R07MS

**SUBJECT: RECALL R07MS BRAUN WHEELCHAIR LIFT  
NONCOMPLIANCE-THRESHOLD  
WARNING SIGNAL RECALL**

# Service Bulletin 34273

Instructions for Braun Corporation "Public and Private Use" Dual Parallel Arm Lift Threshold Sensitivity Evaluation and NHTSA Compliance Applicable for NL, NCL and NVL Series Lifts

## Threshold Sensitivity Test

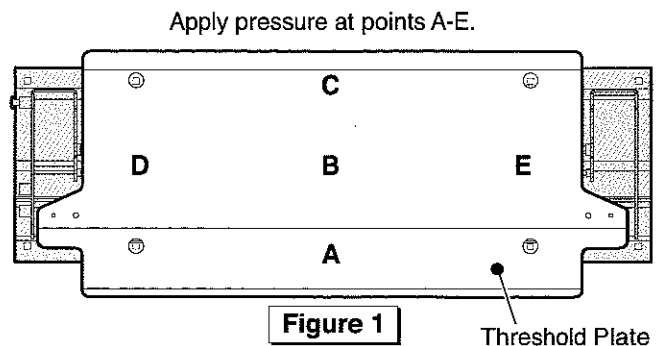
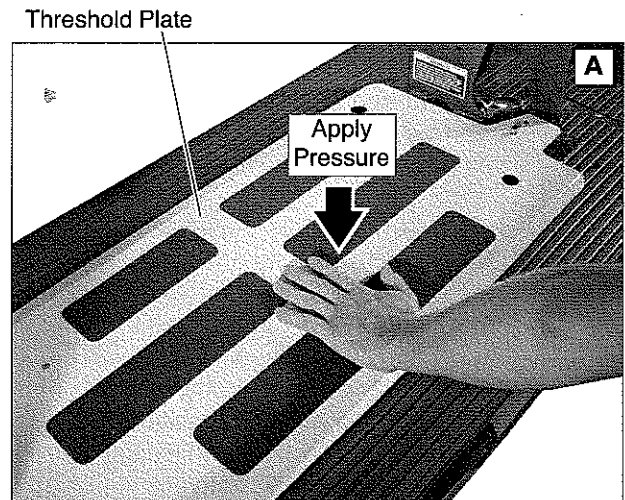
1. Turn Lift Power switch ON. Deploy the lift platform fully to the ground.
2. Apply hand pressure on the center of the threshold plate as shown in Photo A. The visual and/or audible threshold warning\* should be activated when you push down.

Repeat the sensitivity test procedure at positions A-E shown in Figure 1.

3. If the threshold alarm is activated at all positions, no further procedures are required. The lift threshold sensitivity meets NHTSA FMVSS 403/404 requirements.

If the threshold alarm is not activated at all positions, perform the retrofit procedures detailed on pages 2 and 3 of this bulletin. Repeat the sensitivity test procedures following the retrofit. If the lift still does not meet the requirement, contact a Braun Corporation Product Support representative at 1-800-THE LIFT®.

## Threshold Sensitivity Retrofit Instructions

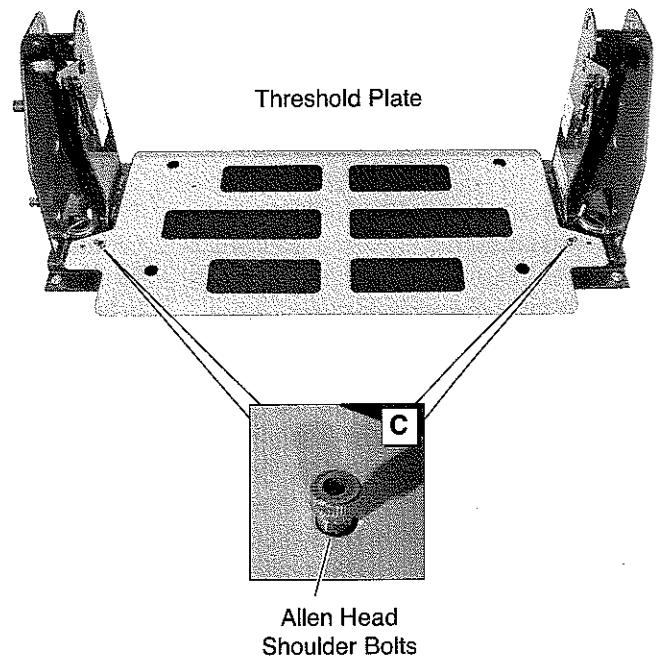
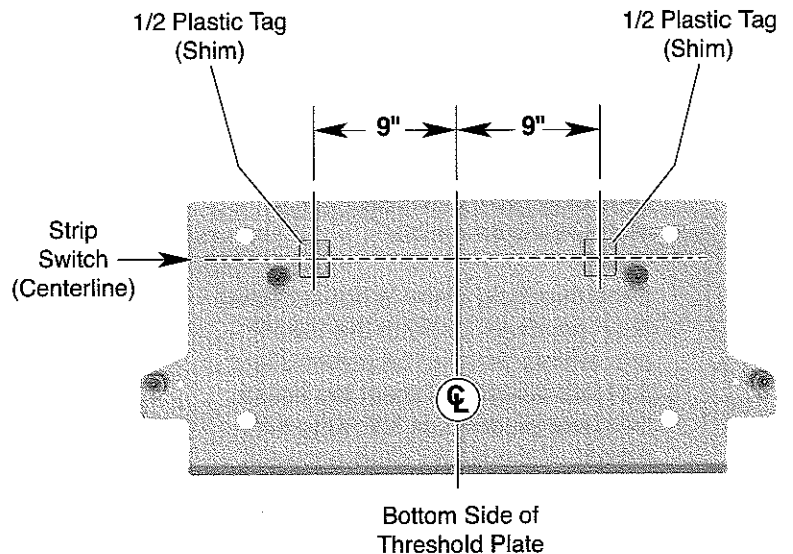
1. Turn Lift Power switch ON. Deploy the lift platform fully to the ground.
2. Remove the threshold plate. Loosen and remove two Allen head shoulder bolts securing the plate (see Photos B and C). Keep bolts. Slide the plate outward and lift to remove it (four keeper standoffs engage key-hole slots). See Photos E, F and G.
3. An adhesive-backed plastic tag is supplied to serve as an alarm activation shim (minimal thickness required to activate the highly sensitive alarm strip switches). Cut the plastic tag in two halves. The plastic tags (shims) will be affixed to the bottom side of the threshold plate (positioned as shown and detailed below).

Turn threshold plate over. See Photo D. The strip switches typically leave an impression (mark) on the yellow plate from use. Use the impression of the inboard strip switch as a centerline for shim positioning (or measure to establish position).

Position each shim 9" from the center of the threshold plate (see Photo D). Align the tags with the strip switch centerline. Clean the surface as detailed below and affix the adhesive-backed tag to the plate (**press firmly**).

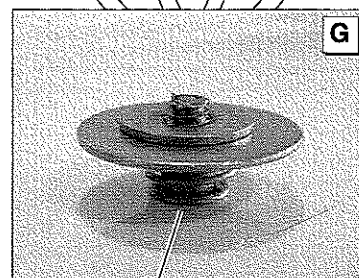
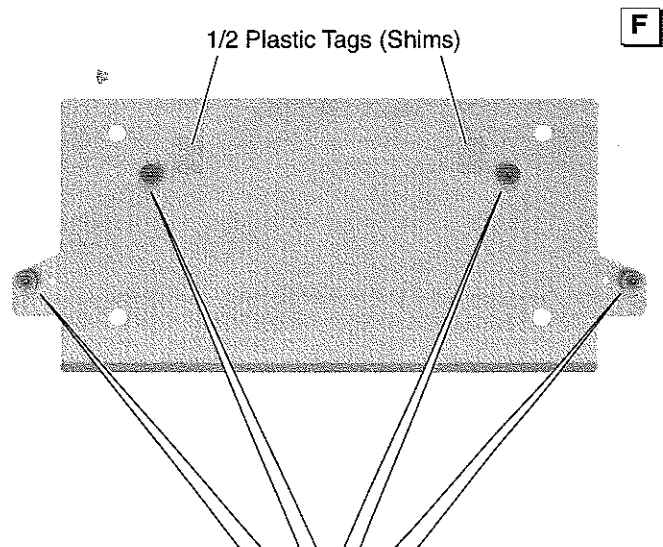
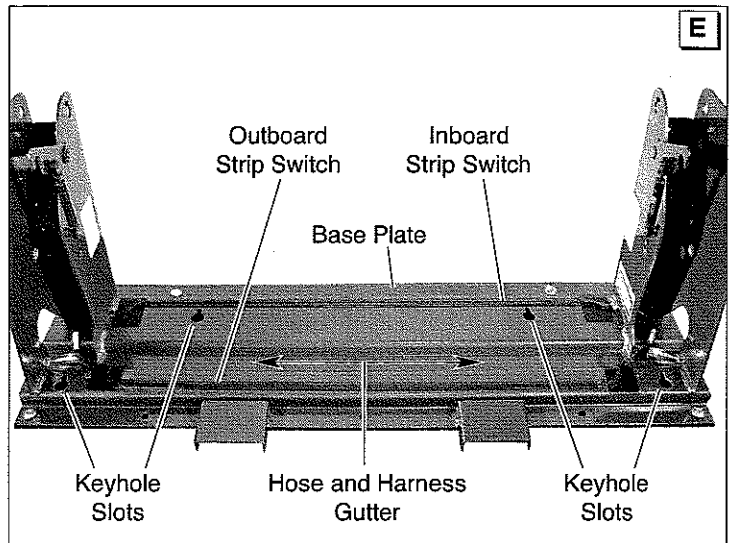
4. Reposition the threshold plate (with shim). Align the keeper standoffs (studs) on the bottom of the threshold plate with the base plate keyhole slots. See Photos E, F and G. Insert studs and **carefully** slide the plate inward (engage slots fully).

**Ensure** all hoses and wiring harnesses routed through the base plate gutter are positioned fully in the gutter and not located anywhere they could potentially interfere with activation of the tape switches. See Photo E.

**Note:** Spraying a light mist of glass cleaner (or other) to the strip switches will aid in the plate sliding easier into position. See Photos E, F and G.

**Ensure** all four keeper standoffs engage the base plate keyhole slots.
